RE: REVISED DRAINAGE PLAN FOR CARPET CONCEPTS BUILDING  
(C-17/D1Z) REVISION DATED MARCH 2, 1988

## DRAINAGE PLAN

LOT 24, CLIFFORD INDUSTRIAL PARK, PHASE II

**DRAIN LINE THROUGH CURB DETAIL \***  
N.T.S.

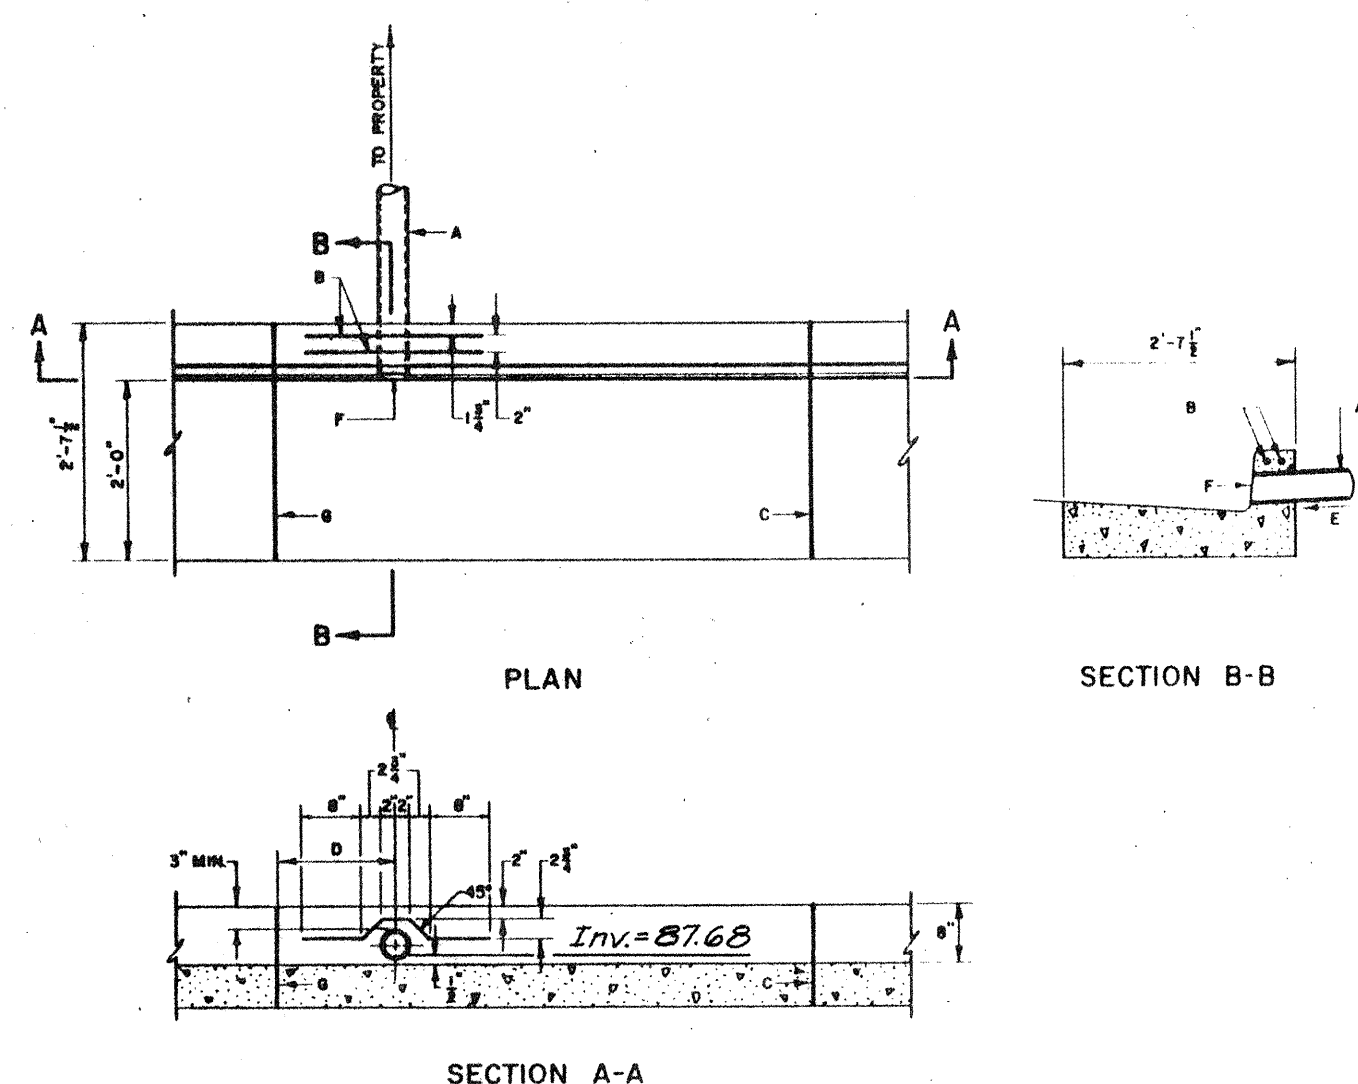
Based on the information provided on your resubmittal of March 4, 1988,  
revisions as indicated are acceptable.

\*REVISED 3-2-88  
Drain Line Thru Curb  
F.F. ELEV. REVISED 10/14/87
